UNITED STATES PATENT AND TRADEMARK OFFICE

APPLICATION NO.	FILING DATE	FIRST NAMED INVENTOR	ATTORNEY DOCKET NO.	CONFIRMATION NO.
10/606,479	06/26/2003	Robert J. Smith JR.	16930-1	5653

Office Action Summary

DETAILED ACTION***Response to Amendment***

Marked up Fig.1

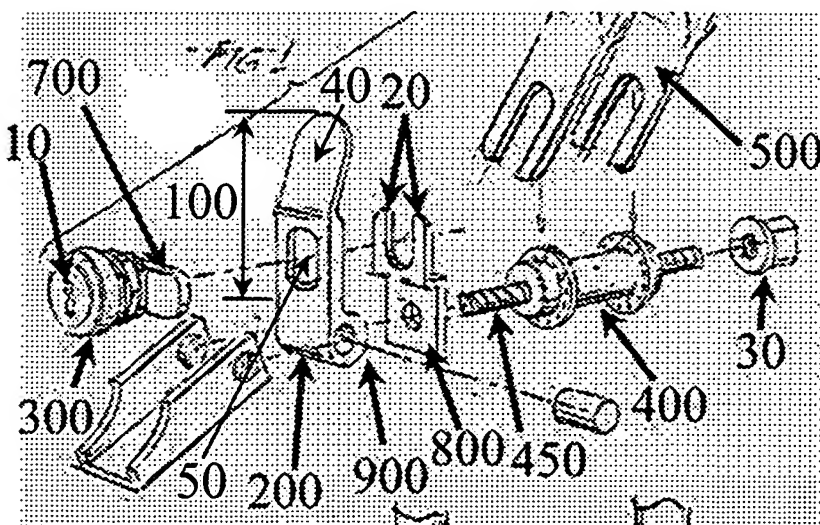
Claims 1-6, 8-13, 15, 18, 19 and 21-23 are rejected under 35 U.S.C. 103(a) as being unpatentable over Katsouros U.S. Pub.20020026816 (see marked-up figures below) in view of Chang U.S. Patent 5479836.

Claim 1. Katsouros discloses a locking quick release device for lockingly affixing a removable component (500) to a fixed component (100, 200 and 400 are fixed to wheel 600), the fixed component having a first member (100, 200) and a second member (400) moveable toward and away from each other between a first position (as seen in fig.2) in which the removable component is affixed to the fixed component and a second position (seen in fig.3) in which the removable component is removable from the fixed component, said locking quick release device comprising: a lever (100, 200) having a handle end (100) and a pivot end (200), the lever being movable about the pivot end between an open position and a closed position so that movement of the lever to the closed position causes the members to move to the first position and movement of the lever to the open position causes the members to move to the second position; and a locking mechanism (300) operatively combined with the handle end of the lever to selectively prevent movement of the lever about its pivot end when the locking mechanism is actuated into a locked position. Katsouros discloses that the removable component is a set of bicycle forks (500). Katsouros does not disclose a seat post. Chang teaches (figs. 3-5, 8 and col.1-4) a removable component that is a bicycle seat assembly (B), and that a locking quick release device is attached to the bicycle seat assembly, for the purpose of securing a bicycle seat assembly against theft. Therefore, it would have been obvious to one with ordinary skill in the art at the time the invention was made to modify Katsouros to be used on a bicycle seat assembly, for the purpose of securing a bicycle seat assembly against theft.

Claim 2. Katsouros as modified by Chang suggests that locking mechanism has a latching mechanism (700); and a receiving member (800) is combined with the fixed component for receiving the latching mechanism to provide for locking of the lever to the fixed component and

Claim 6. Katsouros discloses wherein the lever further comprises a cam surface (900) near the lever pivot end so that movement of the lever to the closed position moves the first and second members to the first position in which they are closer together, and movement of the lever to the open position moves the first and second members to the second position in which they are farther apart.

Claim 8. Katsouros discloses that the locking mechanism has a first end (near 700) and a second end (near 10) with a key slot (10) at the second end, said key slot being adapted to receive a key.

The applicant argues that the prior art does not disclose the claim 1 limitation “a locking mechanism operatively combined with the handle end of the lever...”. This is not persuasive. Katsouros discloses (as seen in the marked-up figures above) a locking mechanism (300) **operatively combined** (in that 300 and 100 are parts of a common assembly) with the handle end (100) of the lever (100, 200) (emphasis added). The applicant should note the following:

Marked-up Fig.2

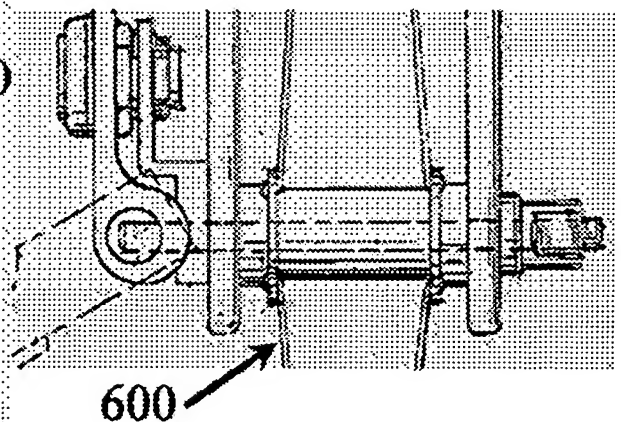
Claim 13. Katsouros discloses a bore (where 200 and 400 receive 450) through both the first and the second members; an opening (50) in one of the members; a threaded member (450) having a first end (right end of 450) and a second end (left end of 450) with threads on the first end, said threaded member second end combined (at 200) with the lever near the lever pivot end, said threaded member passing through the bore; and a thumb screw (30) threaded onto the threaded member first end so that a portion of the thumb screw extends (30 extends from right side of opening in 400) from the opening in the member, said thumb screw capable of moving the first and second members closer together and farther apart when the thumb screw is moved relative to the threaded member.

between two holding members (500) tightened by a movable lever (100) that includes a locking mechanism (300) that is engaged with a receiving member (20), said method comprising: inserting the removable component (400, 450) between the holding members; tightening the removable component between the holding members by moving the lever (100); moving the lever to a closed position (as seen in fig.2) wherein a portion of the locking mechanism becomes engaged with the receiving member; and operating the locking mechanism so that the lever is locked in the closed position. Katsouros discloses that the removable component is a set of bicycle forks (500). Katsouros does not disclose a bicycle seat assembly. Chang teaches (figs. 3-5, 8 and col.1-4) a removable component that is a bicycle seat assembly (B), and that a locking quick release device is attached to the bicycle seat assembly, for the purpose of securing a bicycle seat assembly against theft. Therefore, it would have been obvious to one with ordinary skill in the art at the time the invention was made to modify Katsouros to be used on a bicycle seat assembly, for the purpose of securing a bicycle seat assembly against theft.

claims. Furthermore, the limitation "extend from an opening" does not require "being inside of the opening". Katsouros meets this limitation since (30) is adjacent to and extends from the right side of the opening in (400).
